Docket Item # 5  
BAR CASE # 2016-00361

BAR Meeting  
November 16, 2016

**ISSUE:** Signage  
**APPLICANT:** Nicecream Factory  
**LOCATION:** 726 King Street  
**ZONE:** KR/King Street Retail

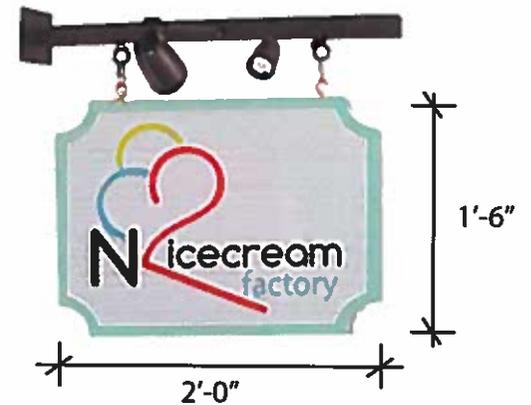
C-1 Proposed signs and store front alterations will comply with zoning. A minimum of 8' from the bottom of the hanging sign to the sidewalk must be maintained.

- C5. A sign may be erected or displayed flat against a building wall or at an angle thereto, so long as the sign does not project more than four feet from the building wall or within one foot of an established curb line and the bottom of the sign is at least eight feet above a sidewalk or parking area and at least 14.5 feet above any alley. (Sec. 5-2-29(c)) (T&ES)

Nicecream Factory Project: 726 King St. Alexandria VA

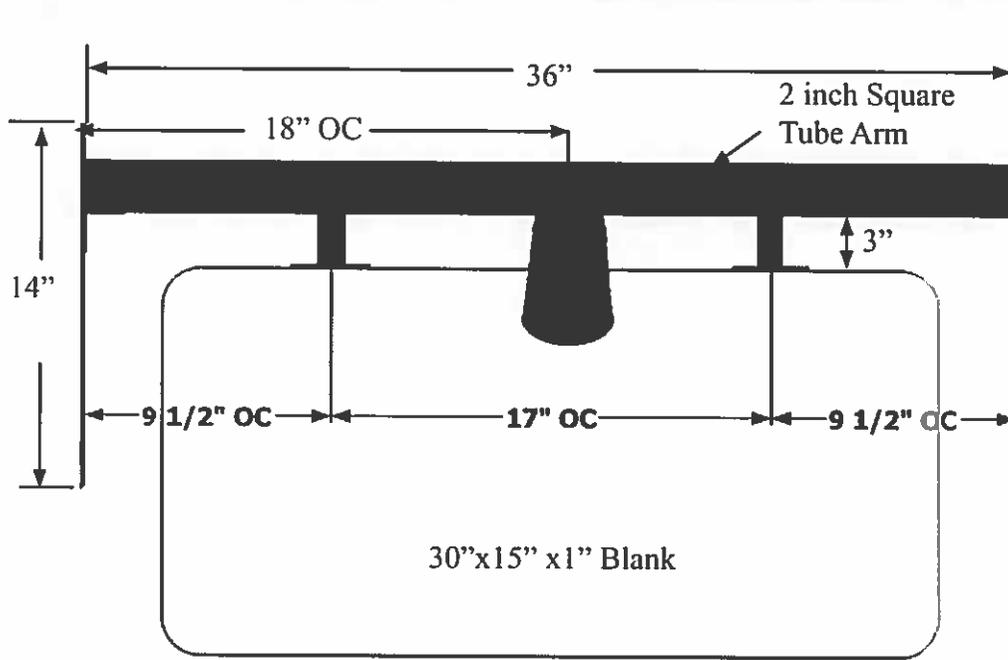
1. Approval of a Certificate of Appropriateness for the wall and projecting signs, provided the LED light strip is integrated into the sign band trim and the lights bulbs are not visible to pedestrians, and
2. Denial of the request to paint or lime wash the unpainted first floor masonry wall.

While the BAR's Sign Policy allows for up to two signs per business, the square footage of the signage exceeds what staff may approve administratively and the applicant must seek Board approval for the signs. Staff has no objection to the signs or their size, given the particularly narrow 14 foot wide storefront and the recessed entrance. However, the applicant should work with staff to review a large scale lighting detail to confirm that the LED lighting can be installed on the sign band so that the fixture itself is not visible and lights do not shine into pedestrian's eyes and that the intensity of the illumination does not visually overpower the streetscape.

Staff also supports the changes to the storefront, which will help to modernize the first floor. However, staff does not support the applicant's request to paint, or lime wash, the first floor brick wall for a number of reasons. The BAR has historically opposed painting brick and the zoning ordinance stipulates that the painting a previously unpainted masonry surface requires review and approval of a Certificate of Appropriateness from the BAR at a public hearing. With few exceptions, the Board has consistently denied such requests. Although the applicant has stated that the painting or lime washing of the wall is intended to lighten up the storefront to make it more inviting, staff believes that the proposed new signage, storefront paving and the painted sign band will be sufficient to achieve this goal. Painting a masonry surface not only potentially traps moisture in the wall, it is also largely irreversible because it is difficult to remove without further damaging the brick.

Although many of the commercial buildings on King Street have a storefront which is a later addition that is stylistically unrelated to the building above, very few brick commercial buildings are painted on just the first floor. With the majority of this narrow storefront being large plate glass, painting the first floor wall gives the second floor brick mass an uncomfortable floating appearance and creates a significant contrast between the first floor and the more traditional historic upper floors. Although a lime wash would not damage the brick to the extent that paint would, staff believes that it is also not appropriate for the same reasons listed above. As a result, staff recommends denial of the request to paint or lime wash the first floor unpainted masonry wall.
